DA-2020/4

Status Application

Development	Residential - multi dwelling housing development comprising the construction of five (5) buildings with a total of 47 dwellings, 109 car parking spaces, associated earthworks, tree removal, internal accessway, landscaping, APZs, stormwater drainage, substation and Subdivision - Strata title
Location	Lot 90 DP 1086429 14 Cosgrove Avenue, KEIRAVILLE NSW 2500

A4.3 - Padmount easements and clearances

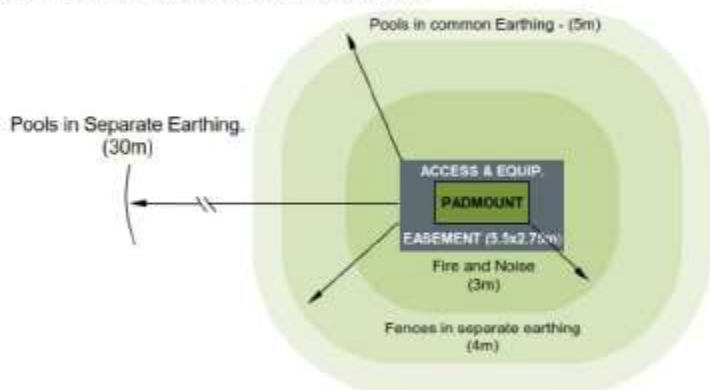
From Endeavour Energy's perspective the fact that provision is being made for the substation is a positive. Endeavour Energy's general requirements is for a padmount substation easement to have a minimum size of 2.75 x 5.5 metres and also have the additional restrictions for fire rating (which usually extends 3 metres horizontally from the base of the substation footing, and 6 metres vertically from the same point and also has regard to any structures etc. attached to the building that may spread a fire) and possibly swimming pools and spas (which in this instance does not appear to be applicable).

The easement and restriction/s should not affect any adjoining property (unless supported by an appropriate easement / restriction). The substation should be at ground level and have direct access from a public street (unless provided with a suitable easement for right of access). The easement and restrictions for the padmount substation are shown in the following extract of the attached copy of Endeavour Energy's Mains Design Instruction MDI 0044 'Easements and Property Tenure Rights', Figure A4.3 'Padmount easements and clearances'.

Generally it is the Level 3 Accredited Service Provider's (ASP) responsibility (engaged by the developer) to make sure that the substation location and design complies with Endeavour Energy's standards the suitability of access, safety clearances, fire ratings, flooding etc. As a condition of the Development Application consent Council should request the submission of documentary evidence from Endeavour Energy confirming that satisfactory arrangements have been made for the connection of electricity and the design requirements for the substation, prior to the release of the Construction Certificate / commencement of works.
